ADDENDUM

PROJECT/JOB#: Dawes Middle School, Small IAQ Project/179.019

SUBJECT: Addendum No. – **One (1)**

Supplemental
Drawing No.:
**SD-
A01**

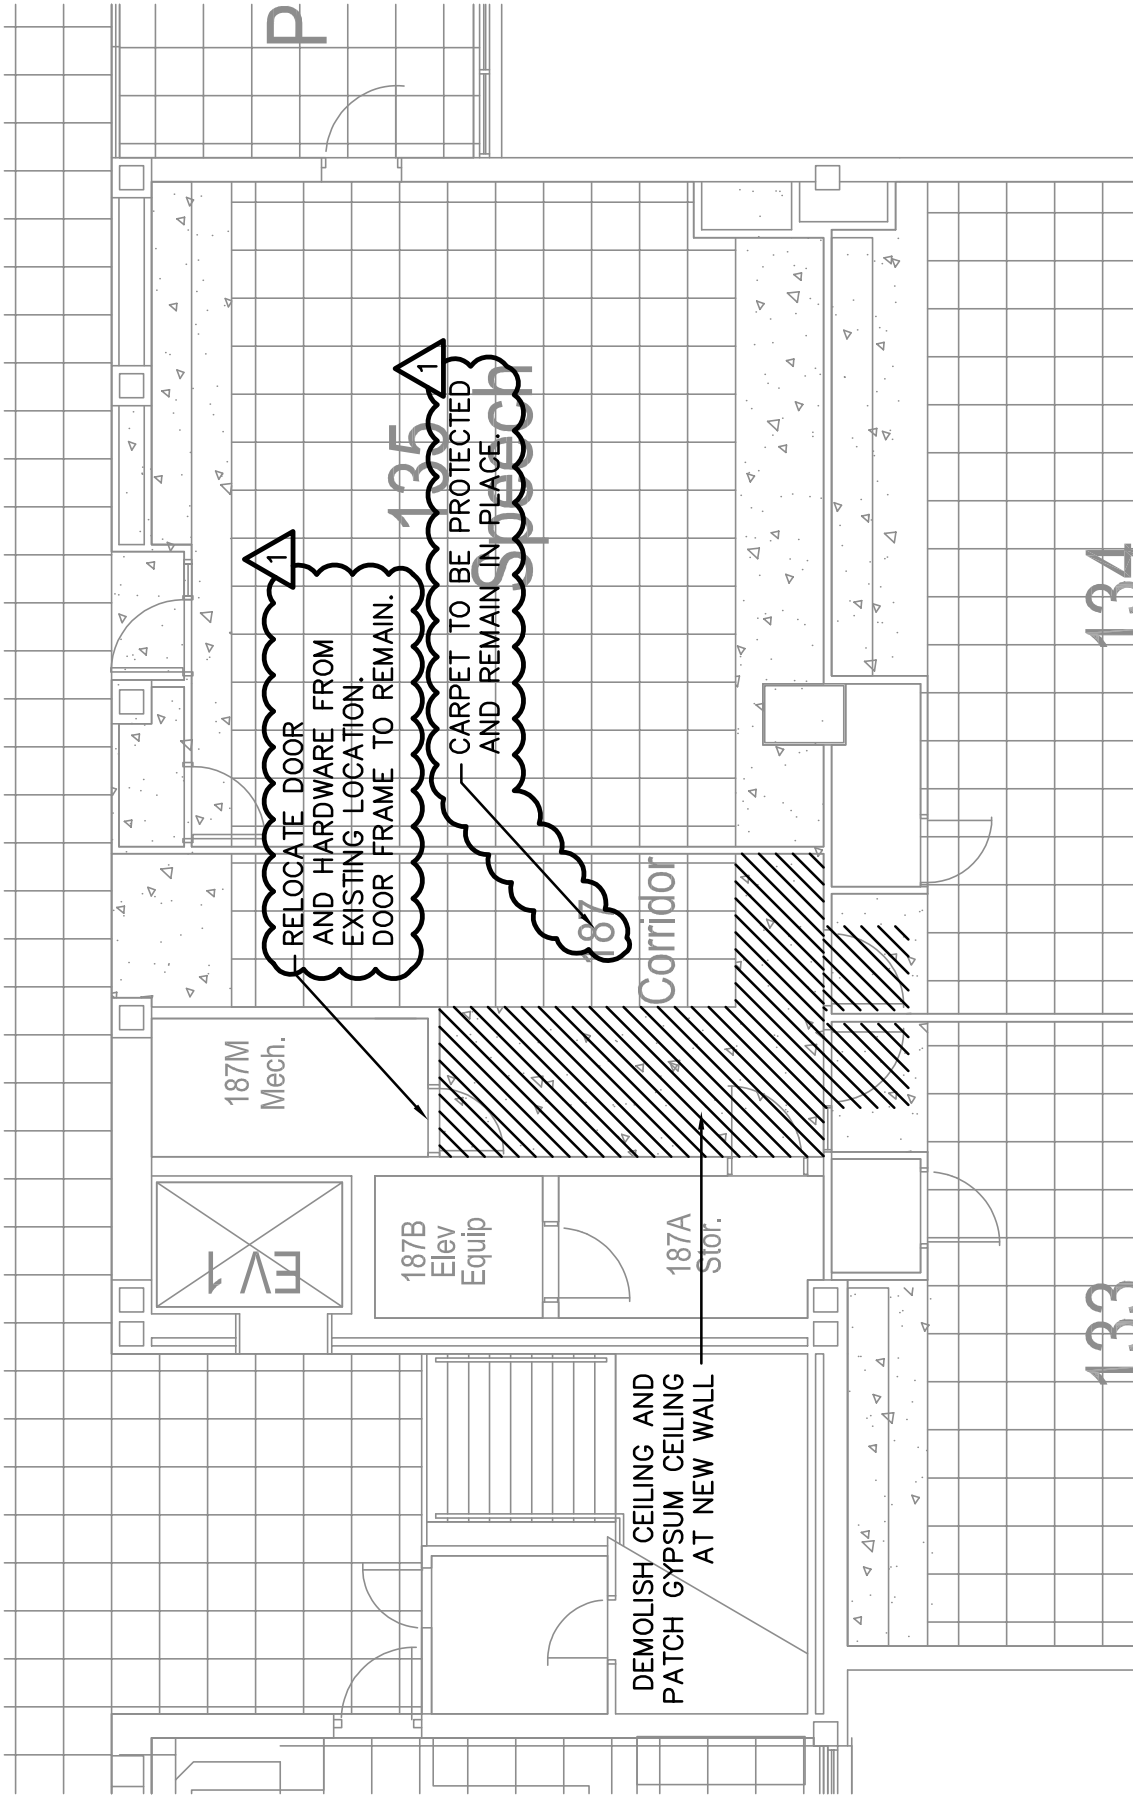
- A. Demolition Floor Plan notes revised/added, refer to supplemental drawing SD-A01
- B. Floor Plan notes added, refer to supplemental drawing SD-A02
